CITY OF PORTLAND, MAINE

September 17, 2018

Project Name: MMC Employee Garage
Project ID: 000207-2018
Address: 190 St. John Street, Portland
CBLs: 64-A-2, 64-A-8, 64-A-9, 64-A-11, 75-A-6, 74-A-7, 68-D-13, 68-D-14, 68-D-16, with off-site improvements at 64-A-1 and 68-D-3 and in the public right-of-way
Applicant: Maine Medical Center
Planner: Nell Donaldson

MMC Employee Garage & Associated Site Improvements
190 & 222 St. John Street
Level III Site Plan
Project #000207-2018

Figures 6 & 7: Final site plan, showing proposed parking structure and adjacent site improvements (top) and rendering from the D Street entrance (bottom)

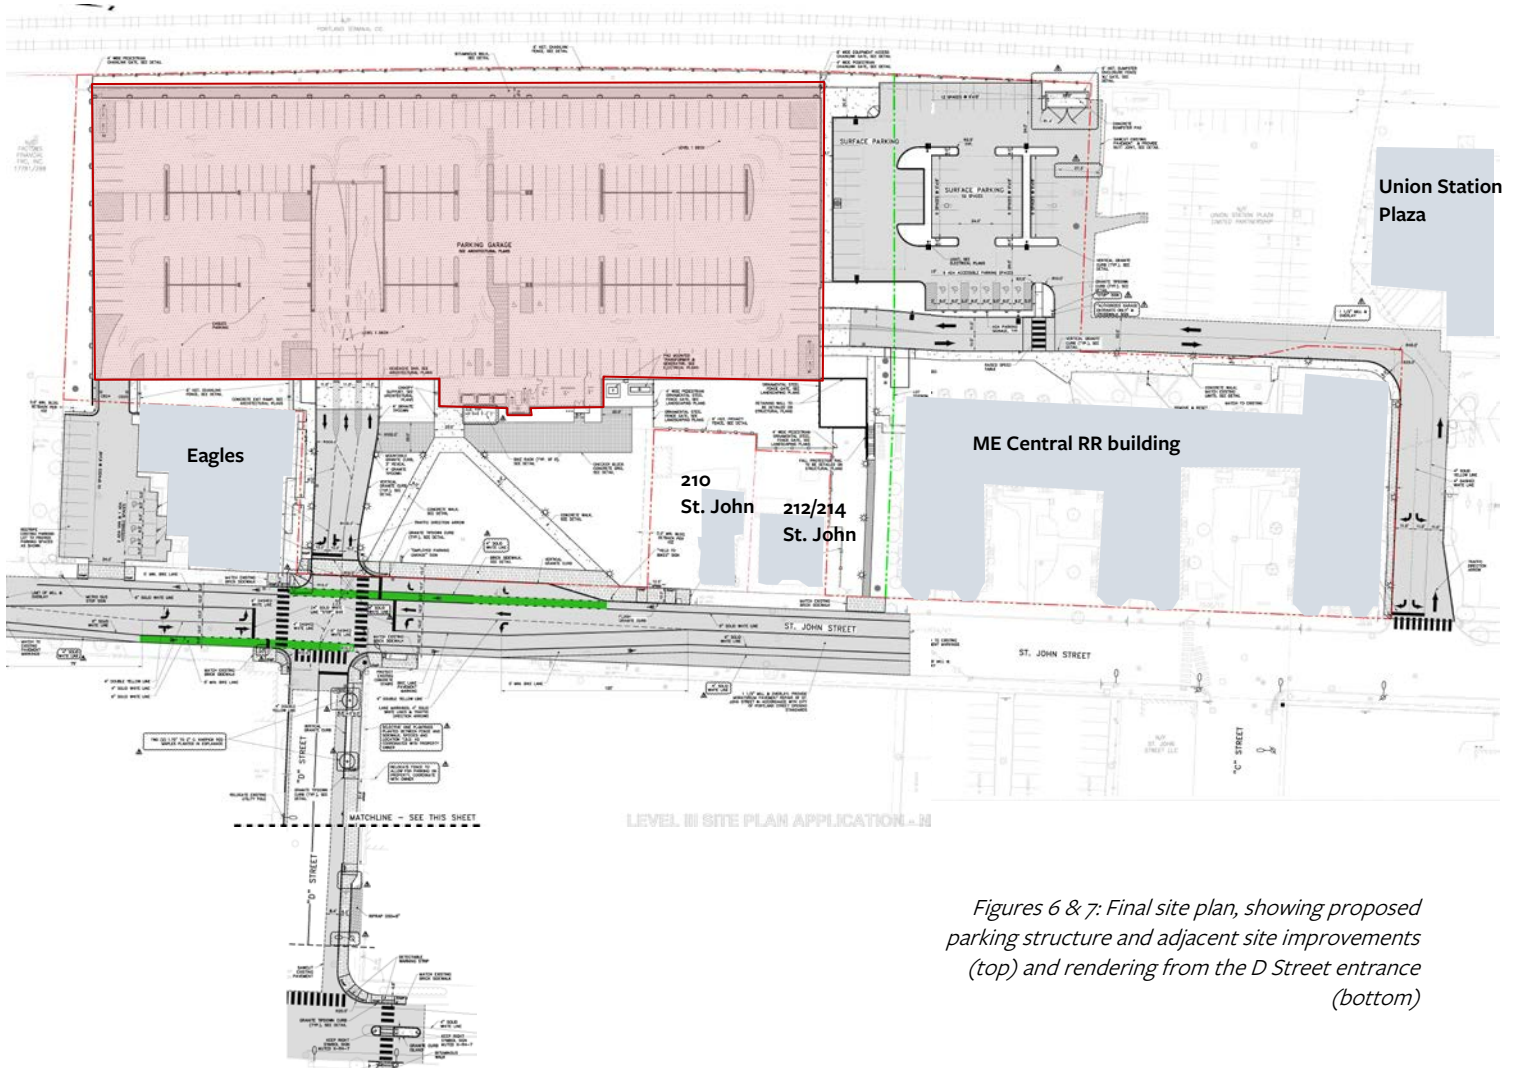
Further revisions to the Site Layout and Material Plan 1 C-100 are to be made -

The final Pavement Marking and Signage Plan(s) is to be revised and approved by DPW and the Planning Authority for corrections, including but not limited to correcting the striping around the refuge island on Valley Street, the bike lane pavement markings on St. John Street, and the "Yield to Bikes" sign

Revise the design of the curb ramp on the SW corner of St. John at the garage driveway to eliminate the skewed area with the vertical curb next to the ramp flares between the curb ramps

The site plan is not consistent with C-104 Utility plan - the utility pole placement on C-100 on the SE corner is incorrect.

3. The applicant shall submit a revised site plan including:
 - i. Revised striping around the refuge island on Valley Street;
 - ii. Revised bike lane pavement markings on St. John Street;

- iii. "Yield to Bikes" sign;
 - iv. Modified label for CB30 on D Street to not obscure the light fixture;
 - v. revised design of the curb ramp on the SW corner of St. John at the garage driveway to eliminate the skewed area with the vertical curb next to the ramp flares between the curb ramps; and

- vi. Revised utility pole placement consistent with C-104 Utility plan

Figure 10: Proposed off-site pedestrian improvements

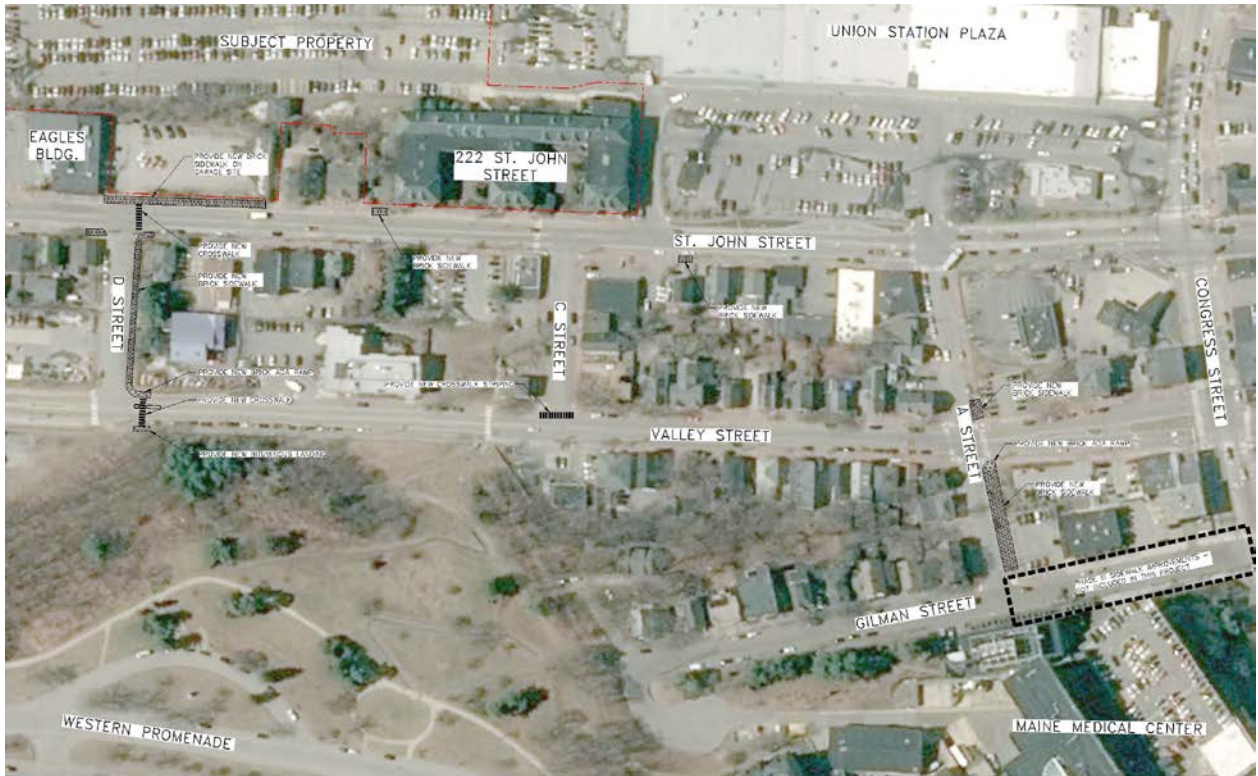
The final site plan site plan shows some significant changes to the configuration of St. John Street along the front of the site near the D Street entrance, including the addition of left-turn lanes in both the northbound and southbound directions and a southbound right-turn lane into the garage entrance. In order to accommodate these turn lanes, through movements, and bicycle lanes, the elimination of approximately 13 on-street parking spaces is proposed. As noted above, neighbors have raised concerns about this proposed loss of on-street parking. Neighbors have also raised concerns about access to and from adjacent residential driveways, particularly at 210 St. John and 212/214 St. John.

Figure 11: Western Promenade “goat paths”

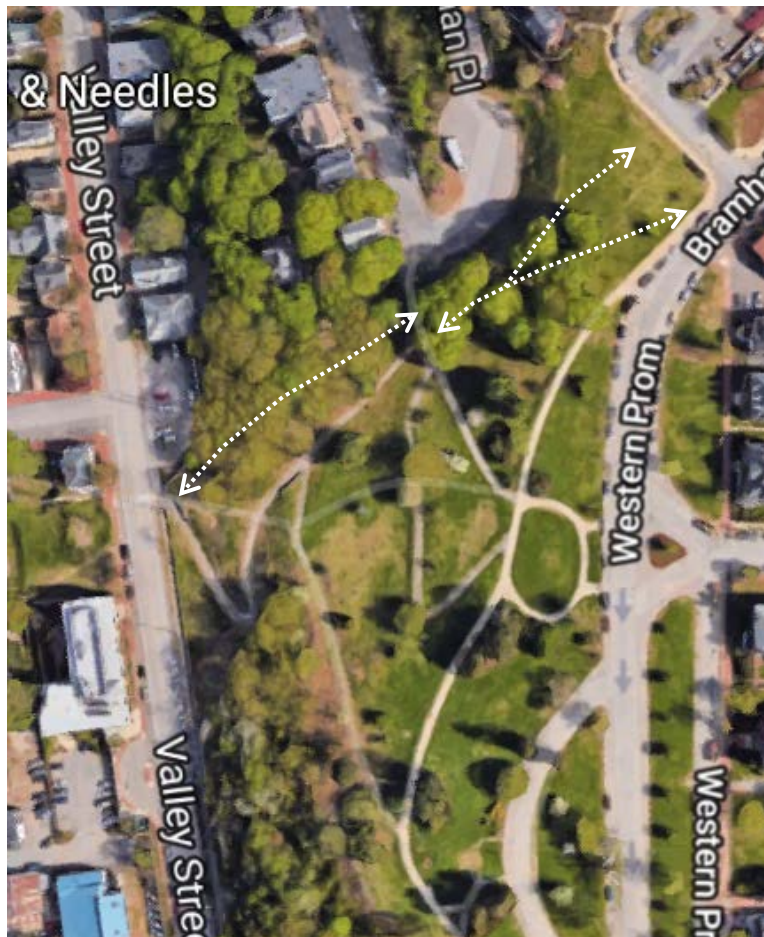
For the goat paths leading from Valley St to Gilman Place, then up the grassy slope to MMC, we recommend the following:

- *Lower Goat Path (Valley St to Gilman Place): At Valley Street, create a break in the retaining wall with stairs leading to the lower goat path. Install timber box stairs and stone dust fill on steep, eroded sections of trail.*
- *Upper Goat Path (Gilman Place to MMC): Combine braided system of multiple goat paths into a single improved trail. Install timber box steps and stone dust fill on steep sections. Alternative is to pave this section of trail.*

11. The applicant shall submit a plan for trail improvements associated with employee pedestrian access through the Western Promenade for review and approval by the Planning Authority, the Parks Department, and the Historic Preservation staff. Following approval, MMC will be responsible for funding such improvements at an amount not to exceed \$50,000.
